Access Compliance Report

Public Rights-of-Way

Intersection ID: 2827	Main Street: DERVISH_LN	Cross Street: SWALLOW_TAIL_LN	Location: W
ADA ID: D60BC09E6F4B	Ramp Type: BlendTrans1	Initial Pass/Fail: Fail	Overall Compliance: No
			Severity Score: 33.75

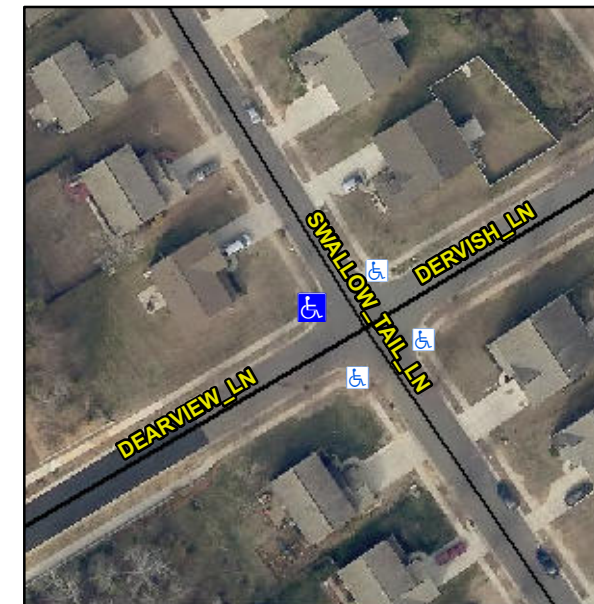
Not Found, R304.5.1, R304.5.3

Compliance	Description	Data	Compliance	Description	Data
N/A	Ramp Length (in)	47.0	Yes	BlendTrans Slope (%)	3.6
No	Ramp Width (in)	39.0	No	BlendTrans XSlope (%)	10.2
N/A	Flare Type LT	N/A	N/A	Flare Type RT	N/A
N/A	Flare Slope LT (%)	N/A	N/A	Flare Slope RT (%)	N/A
N/A	Flare Traversable LT?	N/A	N/A	Flare Traversable RT?	N/A
N/A	Landing Length (in)	N/A	N/A	DWS Provided?	N/A
N/A	Landing Width (in)	N/A	N/A	DWS Contrast?	N/A
N/A	Landing Slope (%)	N/A	N/A	DWS Length (in)	N/A
N/A	Landing X Slope (%)	N/A	N/A	DWS Full Width?	N/A
N/A	Landing Curb? (Y/N)	N/A	N/A	DWS Offset (in)	N/A
N/A	Shared Landing?	N/A			
N/A	Gutter Ponding?	N/A	N/A	Gutter Slope (%)	N/A
N/A	Gutter Lip Ht (in)	N/A	N/A	Gutter X Slope (%)	N/A
N/A	Painted X Walk1?	No	N/A	Painted X Walk2?	No
	X Walk 1 Direction	To SE		X Walk 2 Direction	To NE
	X Walk 1 Width (in)	N/A		X Walk 2 Width (in)	N/A
	X Walk 1 Slope (%)	5.2		X Walk 2 Slope (%)	3.6
	X Walk 1 X Slope (%)	6.5		X Walk 2 X Slope (%)	6.2

N/A	Ramp inside XWalk1?	N/A	N/A	Ramp inside XWalk2?	N/A
	Road Slope (%)	7.4		Clear Space?	N/A
	Road X Slope (%)	3.1	N/A	Clear Space to XWalk (in)	N/A
N/A	Any Obstructions?	N/A	N/A	Storm Grate/Utility Hazard?	N/A
	Obstruction Type			Storm Grate/Utility Type	
		N/A			N/A
			Yes	Surface Condition? (G/P)	Good
			No	Curb Slope (%)	16.9

Remove & Replace Curb Ramp With Two New Directional Ramps or Equivalent.
